ADDENDUM NO. 02

PROJECT: N. Rockland CSD - Stony Point ES Student Drop Off Loop & Water Heater Replacement - Contracts 03, 04, & 05

CPL PROJECT NO. R25.17697.00

DATE: June 9, 2025

Drawing No.
C-300

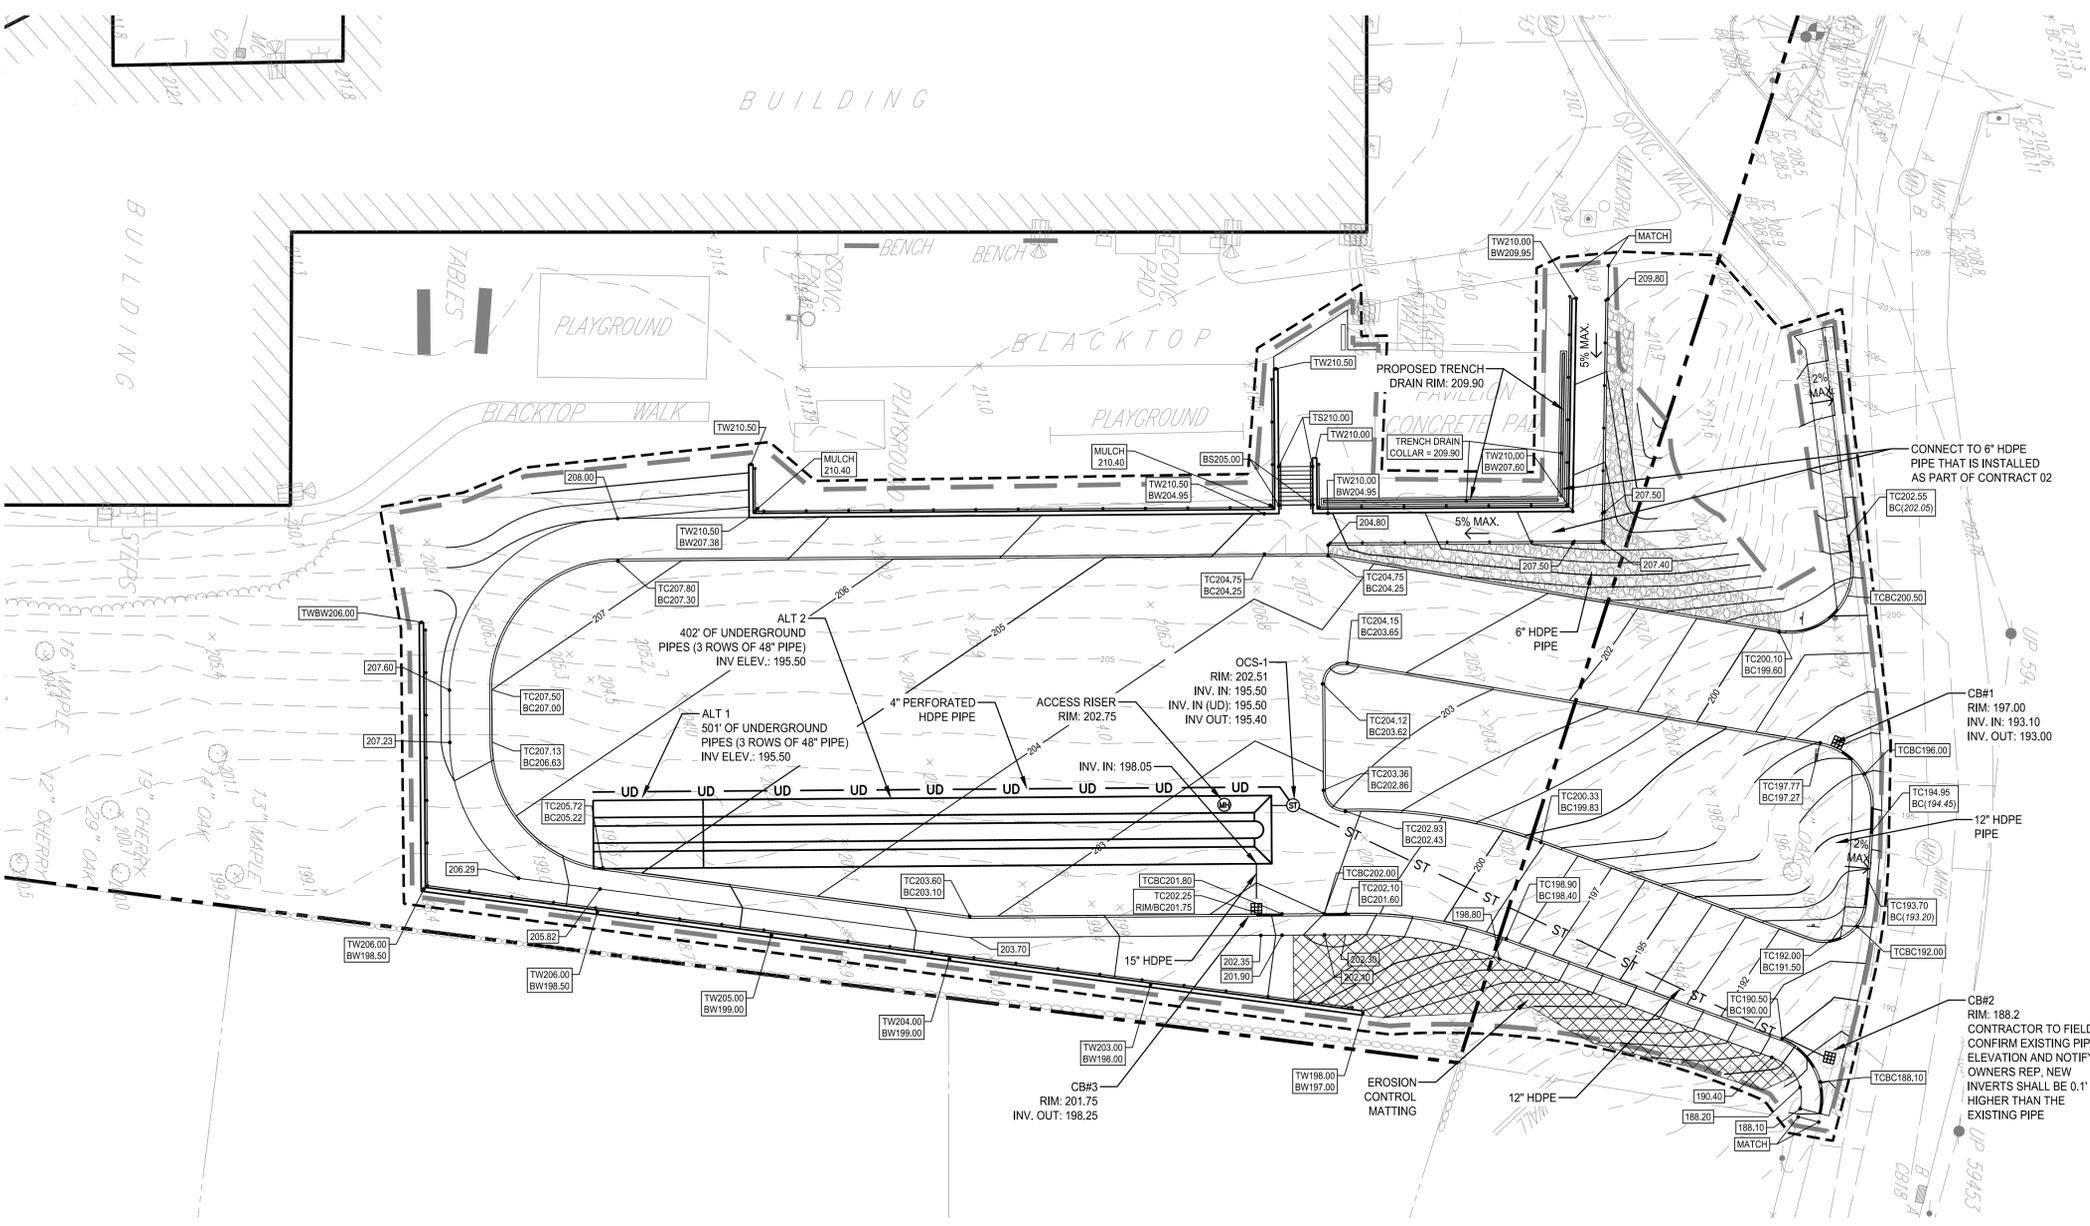
- 2.1 Replace Drawing C300 with the attached, revised Drawing C300.
- 2.2 After Drawing C300, add the attached drawing C301.
- 2.3 After Drawing C502, add the attached drawing C503.
- 2.4 Replace Drawing P200 with the attached, revised P200.
- 2.5 Replace Drawing E050 with the attached, revised E050.

Drawing No.
C-301

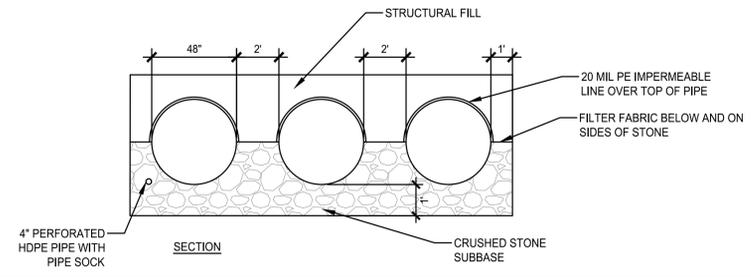
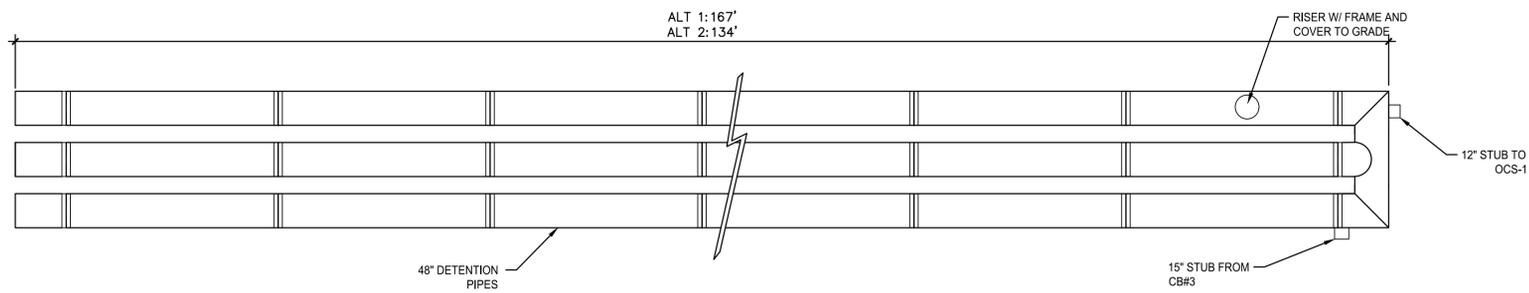
ALT 1:
INSTALL 501 LINEAR FEET OF 48" UNDERGROUND DETENTION PIPING WITH OUTLET CONTROL STRUCTURE AND STORM PIPING CONFIGURATION.
